深圳市灿科盟实业有限公司

PCN 申请书		发行编号			
发 行		发行(供方名)	承 办	审 核	批 准
		灿科盟	覃冰		
	2025-11-18	对贵司所购入品或购入品的质量体系希望发生以下的变化,特此联系。请于 2025 年 11 月 30 日前给出答复。			
适 用 购 入 品	品名	U-MICRM05P-BF13			
	客户规格	Micro usb 5P B型 SMT 四脚加长插板 带柱 卷边			
	客户料号	/			
	分类(打勾)	<input type="checkbox"/> 人、 <input type="checkbox"/> 机、 <input checked="" type="checkbox"/> 料、 <input type="checkbox"/> 法、			
变 更 的 内 容 · 理 由	变更内容:	变更前	变更后		
	变更原因:	因该款四脚加长插板的产品,市场需求较少,已经停产,现建议改用常规的产品,四脚为普通长度,如上图所示,此变化会对客户安装,焊板会有一定影响,但对产品的功能无影响。			
	起始变更标志	日期: 2025 年 11 月 18 日	批次:	编号:	
	针对以上联系做出以下回答。				
客户意见	签名:				
最终结果	<input type="checkbox"/> 同意变更。 <input type="checkbox"/> 基本同意, 需生产 ____ PCS, 量试后决定。				
	<input type="checkbox"/> 不同意变更。 <input type="checkbox"/> 其它: _____。				
	承认:	审核:	批准:	年 月 日

产品变更前后对照图片（左边为变更前，右边为变更后）

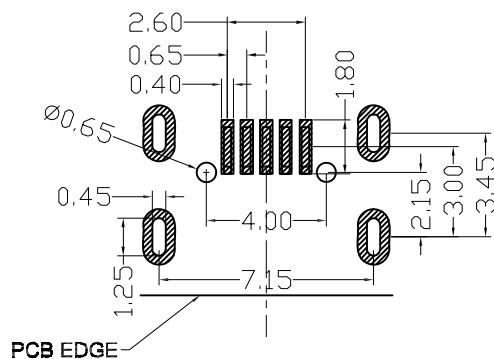
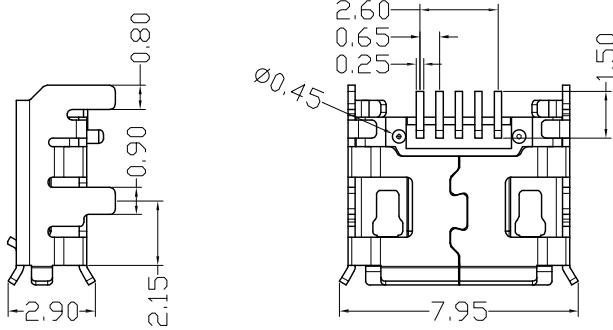
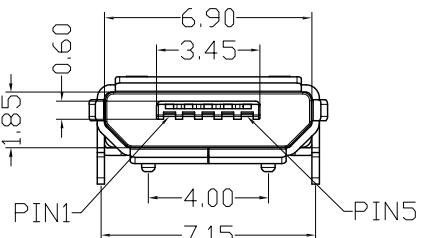
(备注:变更后四个固定引脚会偏短 0.5mm, 客户须评估对焊板是否会有影响)
